United States Patent and Trademark Office

APPLICATION NO.	FI	LING DATE	FIRST NAMED INVENTOR	ATTORNEY DOCKET NO.	ATTORNEY DOCKET NO. CONFIRMATION NO.	
10/697,180	1	0/29/2003	Masanori Minamio	10873.1334US01 8184		
52835	7590	09/08/2005		EXAMINER		
•	HAMRE, SCHUMANN, MUELLER & LARSON, P.C. P.O. BOX 2902-0902				TRAN, LONG K	
	POLIS, MN 55402		ART UNIT	PAPER NUMBER		
	•			2818

DETAILED ACTION

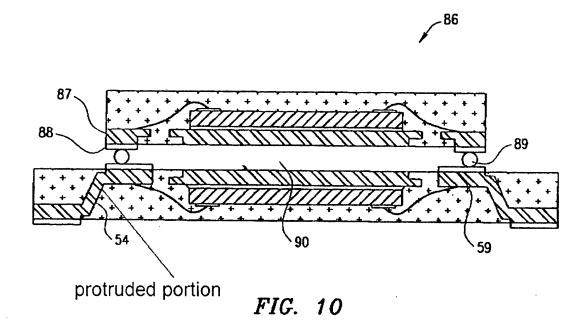
6. Claims **1** and **2** are rejected under 35 U.S.C. 102(e) as being anticipated by Crowley et al. (US Patent No. 6,605,866).

Regarding claim 1, Crowley discloses a lead frame 62 (figs. 2, 3 & 10), comprising:

a frame (figs. 3, 6 & 8); and

a plurality of inner leads 54, 75, 77, 83, 87 (figs. 2 – 14), extending inward from the frame, wherein the inner lead 54, 75, 77, 83, 87 includes a protruded portion provided on a surface of its outer portion, the protruded portion protrudes in a thickness direction, and a step portion is formed in a side portion of the protruded portion.

Regarding claim 2, Crowley discloses the step portion is formed as a portion with two steps (figs. 4 - 14).

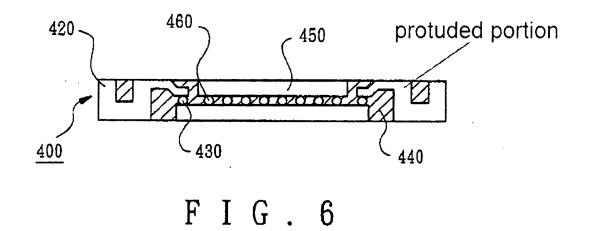
7. Claims **4** – **8** are rejected under 35 U.S.C. 102(b) as being anticipated by Chun-Jen et al. (US Patent No. 6,337,510).

Regarding claim **4**, Chun-Jen discloses a resin-encapsulated semiconductor devices 100/200/300/400 (fig. 5), comprising:

a semiconductor chip 110/210/310/410 (figs. 1-6) having a group of electrodes (not labeled);

a plurality of inner leads 120/220/320/420 (figs. 1-6) that are arranged along a periphery of the semiconductor chip and are connected to the group of electrodes of the semiconductor chip, respectively; and

an encapsulating resin 140/240/340/440 (figs. 1-6; column 2, lines 61-62) that encapsulates a connection part located between the semiconductor chip and the inner leads 120/220/320/420, with a part of each of the inner leads being exposed from the

encapsulating resin to form an external terminal (upper surface and lower surface of the inner leads),

wherein the inner lead 120/220/320/420 includes a protruded portion provided on a surface thereof on an outer side relative to the periphery of the semiconductor chip 110/210/310/410, the protruded portion protruding in a thickness direction with a step portion formed in a side portion of the protruded portion,

the group of electrodes of the semiconductor chip is connected to surfaces of inner portions 122/322/422 (figs. 2,3,5 & 6; 422 not labeled; column 4, lines 18-19) of the inner leads 120/320/420 located on an inner side relative to their protruded portions, through electroconductive bumps 130/330/430 (figs. 1,3 5 & 6; column 4, lines 16-19), respectively, and

the encapsulating resin 140/340/440 encapsulates the semiconductor chip 110//310/410 and the electroconductive bumps 130/330/430 and is formed to expose surfaces of the protruded portions.
